3817 JENIFER ST NW

BZA PRESENTATION

Board of Zoning Adjustment
District of Columbia
CASE NO.21162
EXHIBIT NO. 38

existing
view facing west

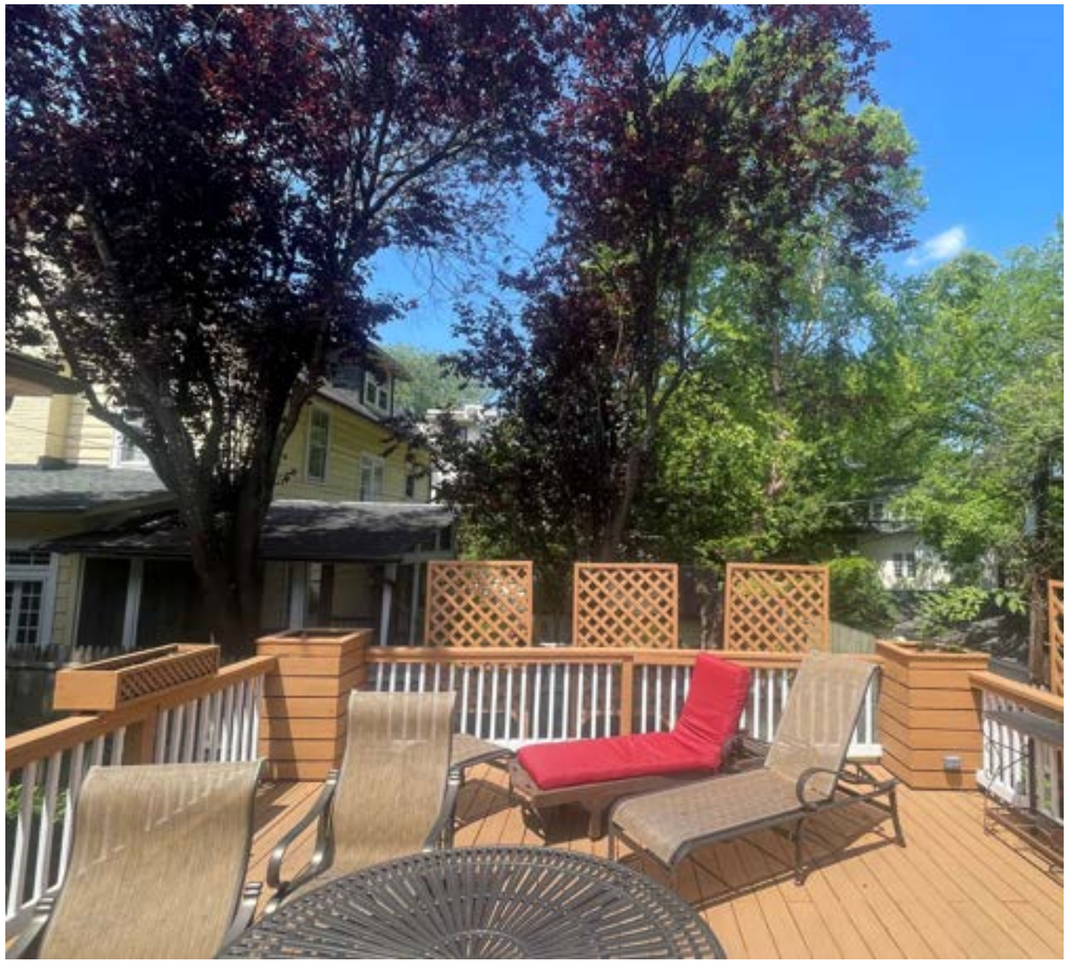
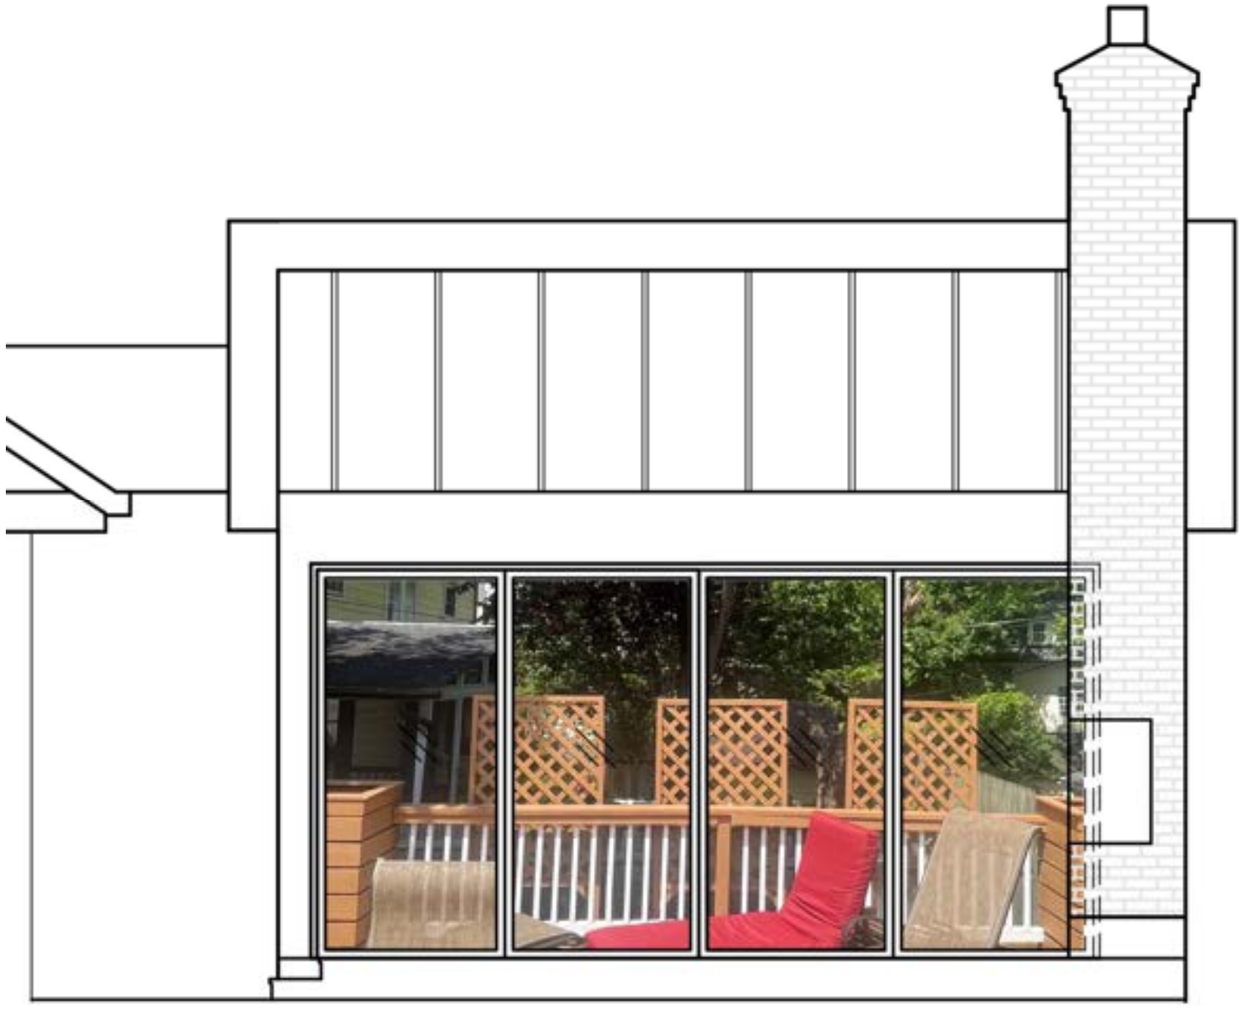
The images above show the east side of 3817 Jenifer St NW. No addition is proposed for this side of the house. Our proposed 1 story addition is on the west side of the property and protected by tree cover. The area above the garage is currently a deck with open sightlines. The proposed addition would limit the visibility towards the alley as well as, rear and side neighbors. The neighbors at 3814 Jocelyn NW will received more privacy, not less. Please reference the existing vs proposed sightlines at addition slide | facing north.

proposed
view facing west
less visibility towards neighbor

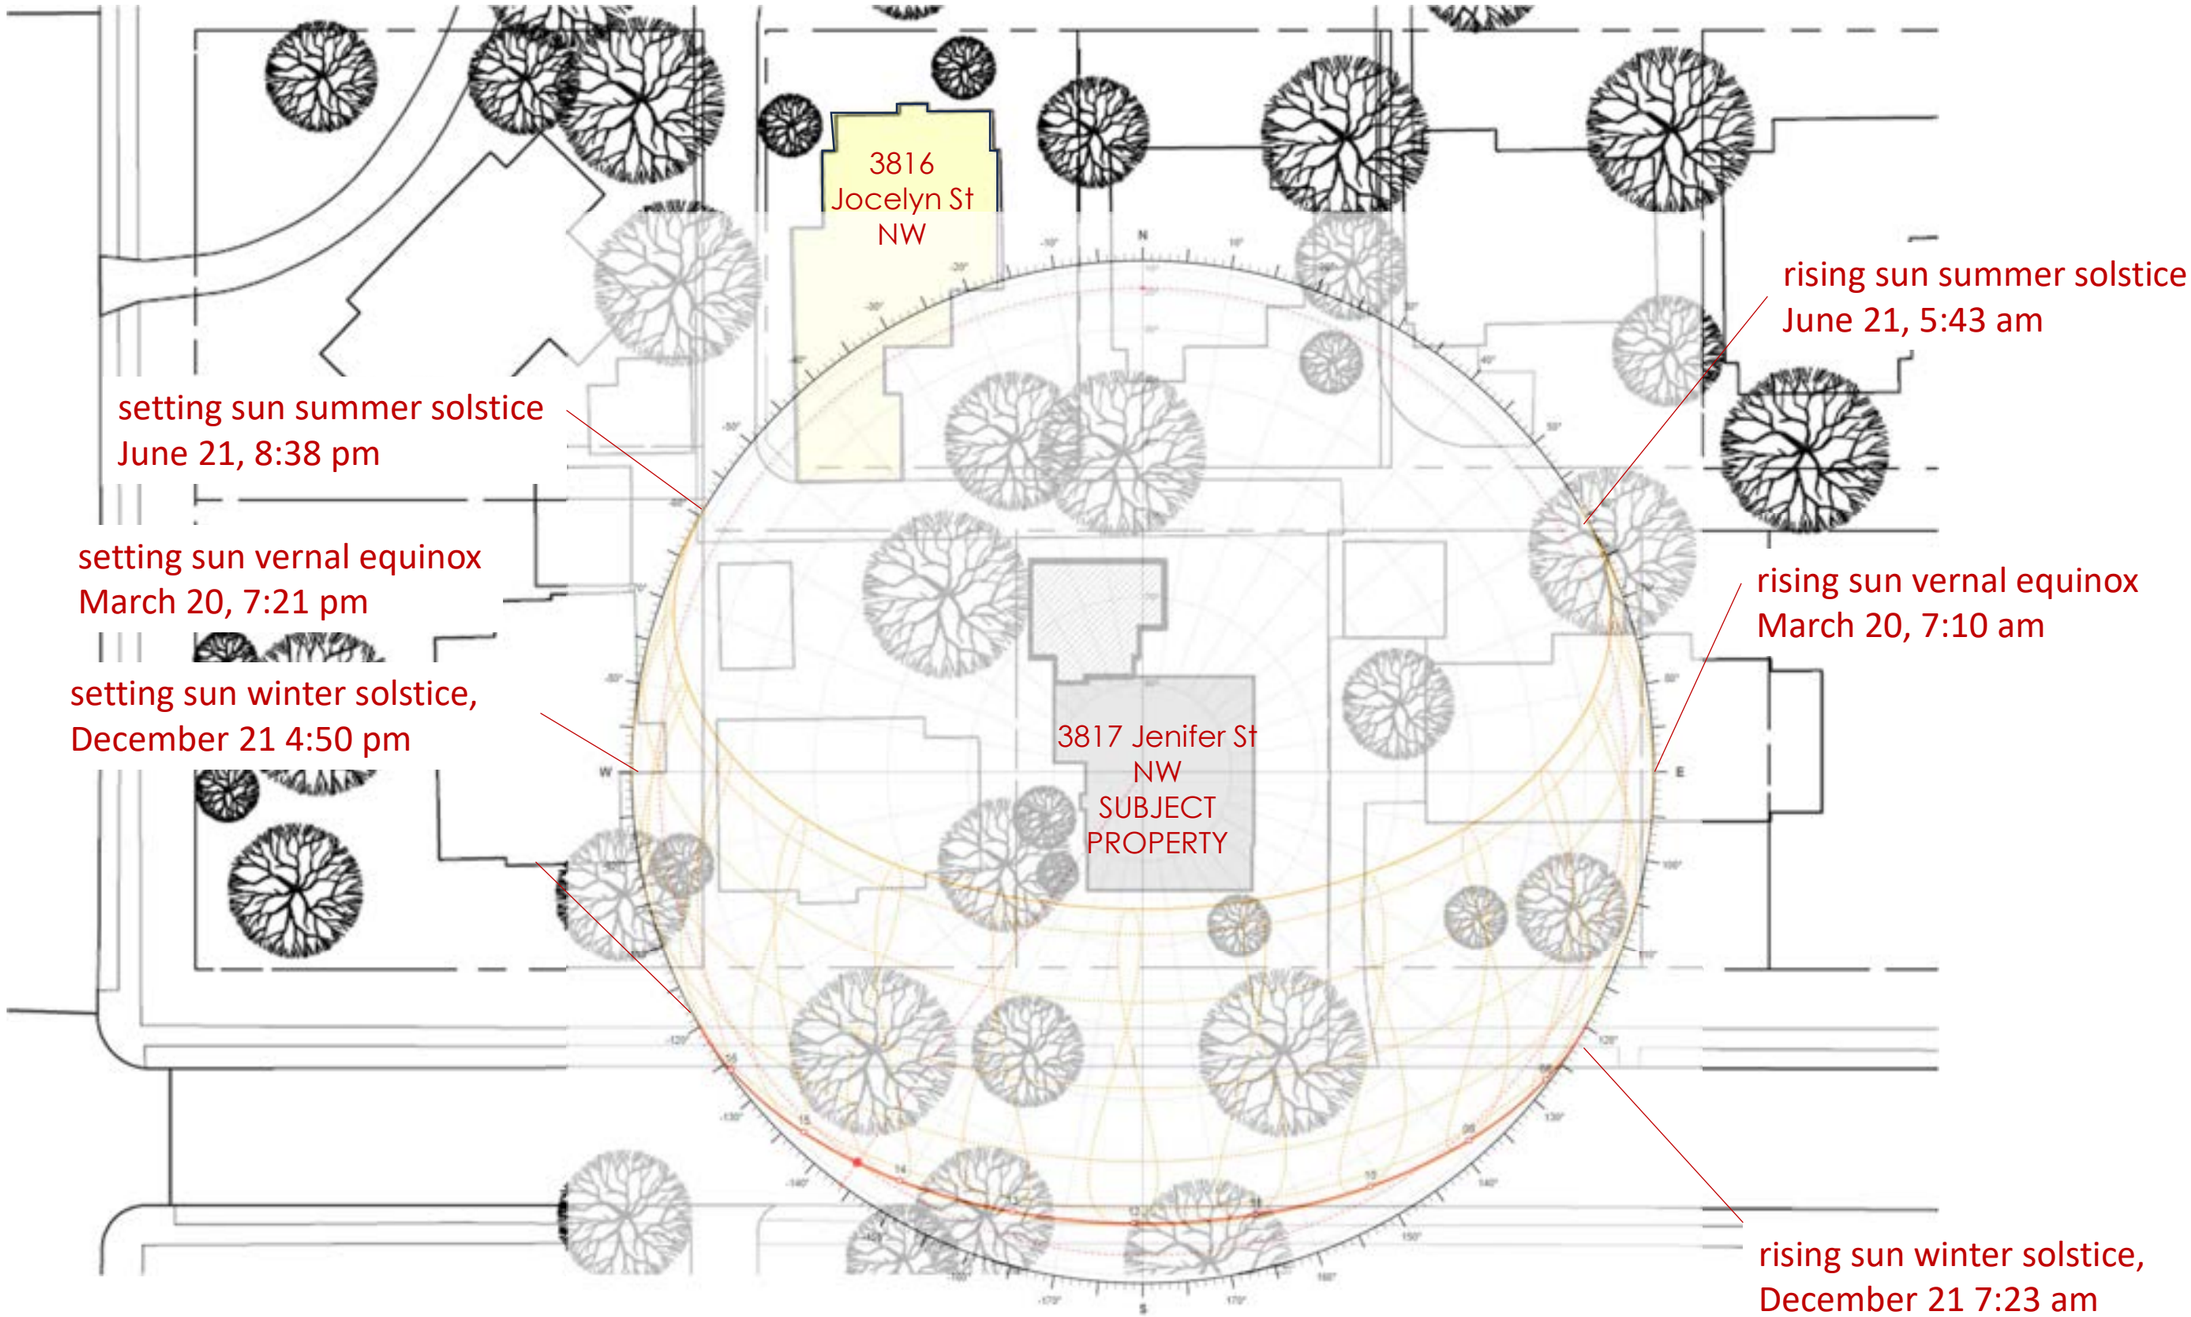
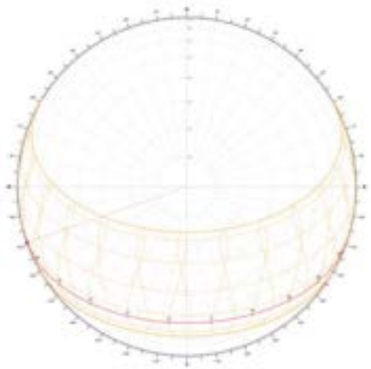
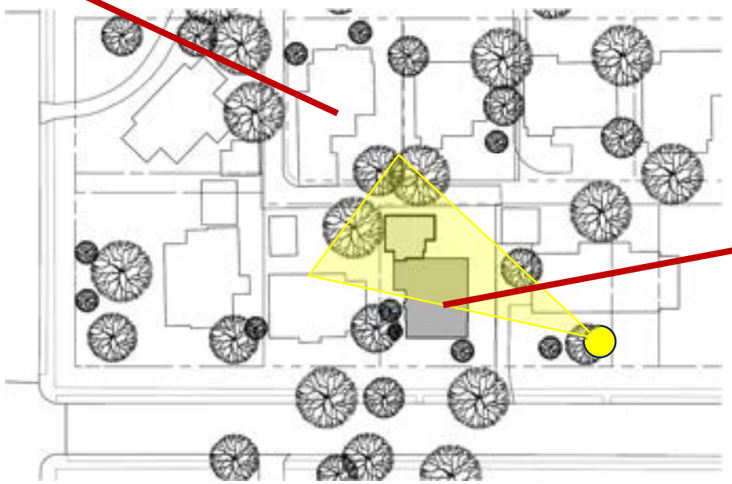
- Despite a request for the applicant to share their air and light impact studies, none have been provided. A twelve-foot-wide alley provides limited separation. At second-story height, with reduced side and rear setbacks and a fireplace, the addition will cast shadows on neighboring yards, patios, and gardens and cause undue impacts on our air quality and our neighbors'.

Impacts to light and air - The impact of an additional story to the rear of the house on the Applicant's property will have minimal impact on light and air for properties located to the north across the alley, and west. The adjacent western neighbor at 3819 Jenifer St NW has signed a letter of support.

OP Report: *"Given the modest height, location above an existing footprint, and substantial side-yard separation to the east, the project would not result in undue impacts to light and air."*
